**Lookout Brook Hydro Plant Refurbishment (Clustered), p. 4 of 96, \$2,155,000**

**Q. In the report provided in Tab 1.2 Lookout Brook Hydro Plant Refurbishment, page 7, NP mentions “arc flash zone of influence”. If NP has investigated the extent of arc flash exposure in its facilities please provide the report that has been prepared. If not, please provide reasons why this investigation has not been undertaken.**

**Lookout Brook  
Arc Flash Hazard Study**

*LBK - 2.4KV FAULT*

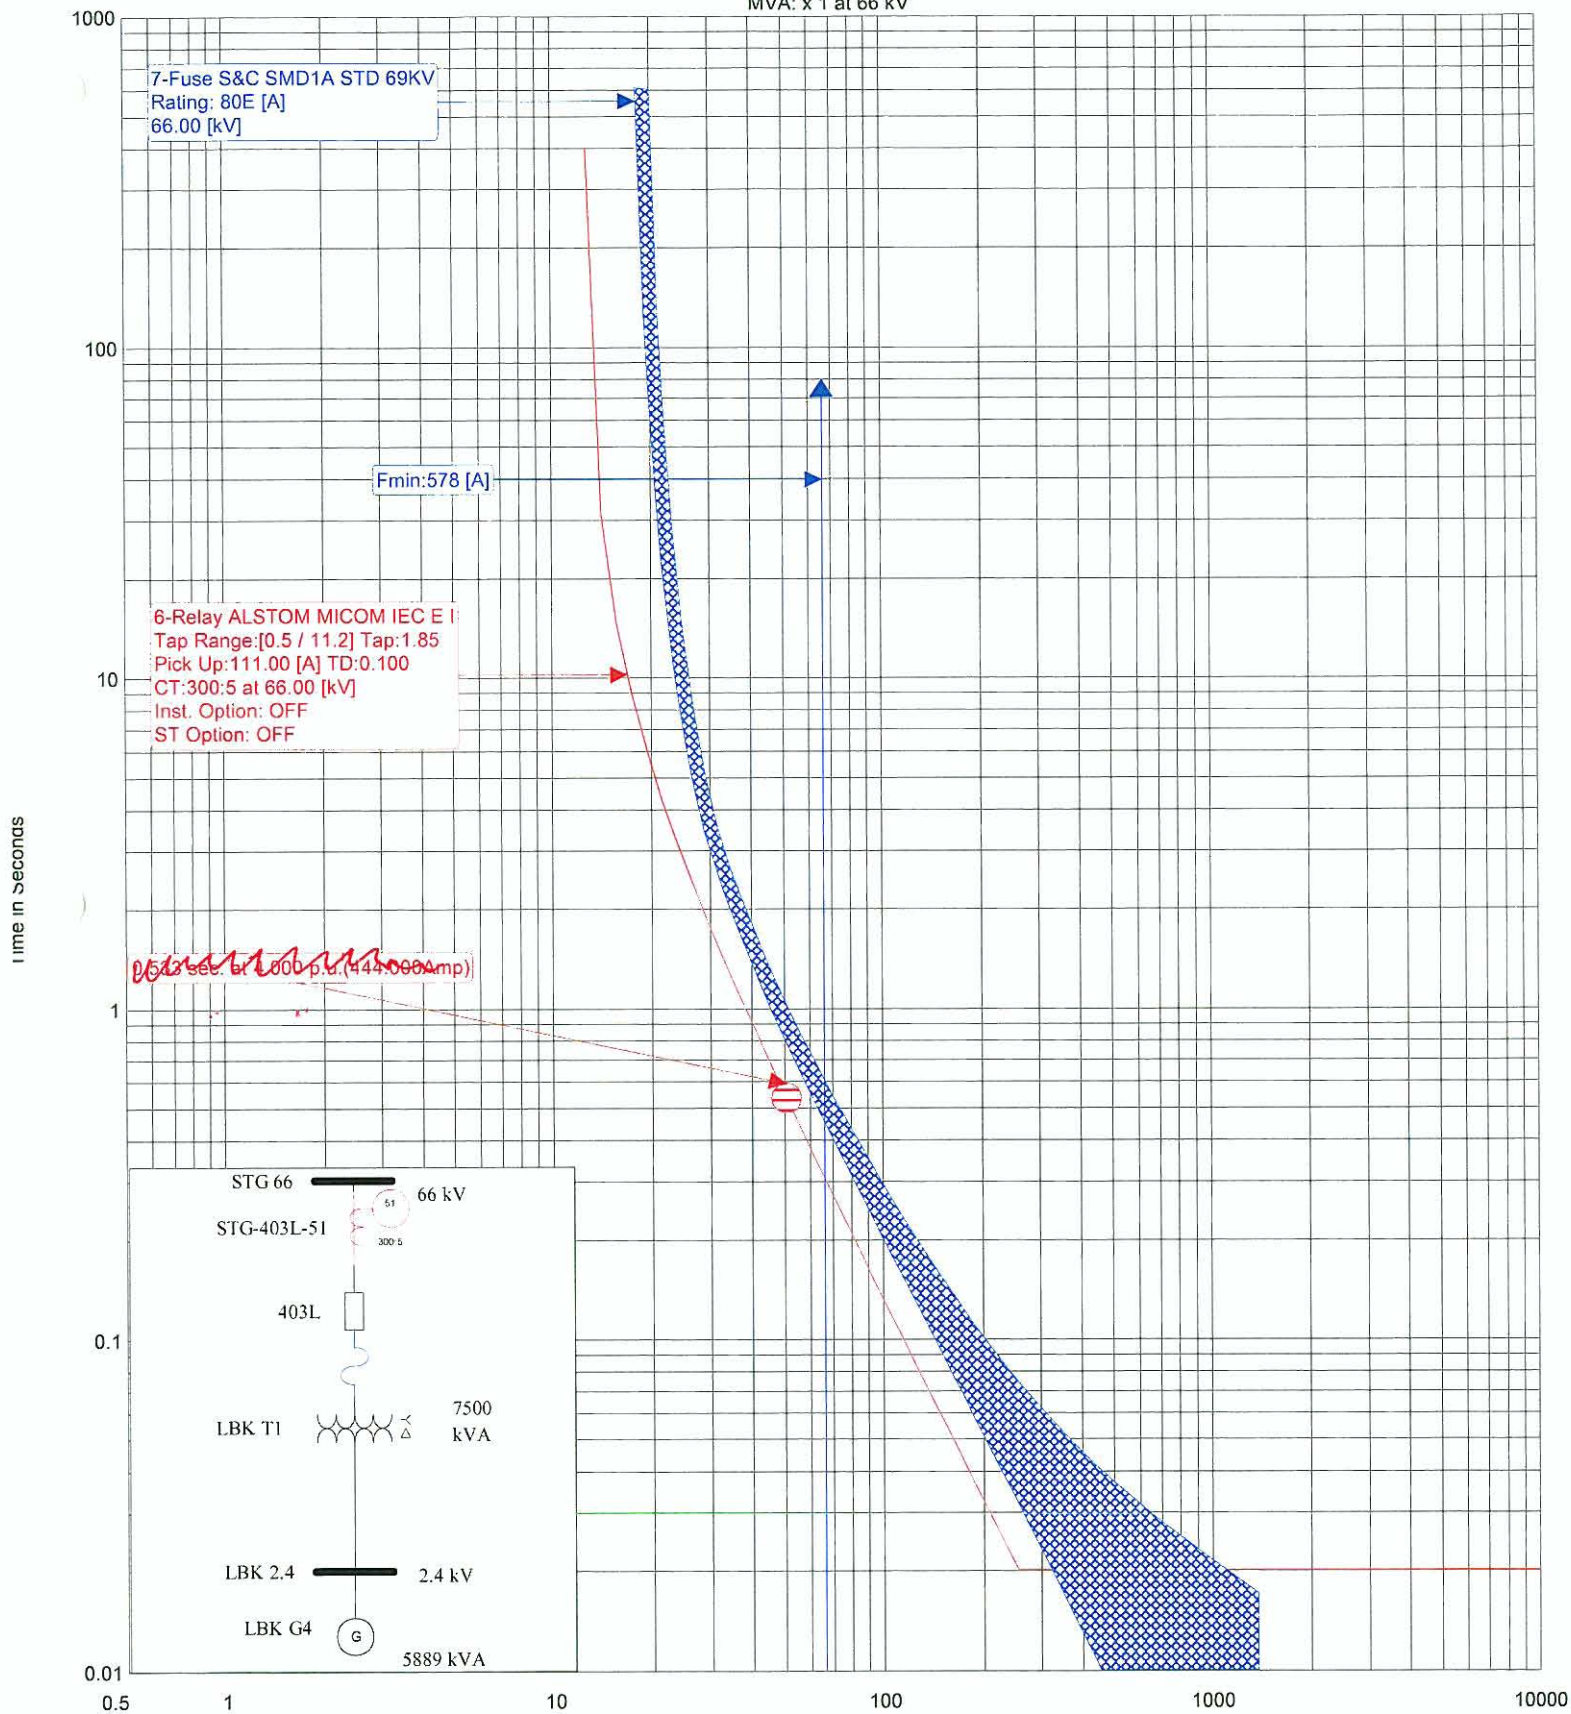
Plot shows miscoordination between Breaker and Fuse.

Miscoordination between STG-403L-B and LBK-T1 fuses for 2.4 kV bus fault.  
Used fuse Clearing Time for Arc Flash Study as this would be worst case.
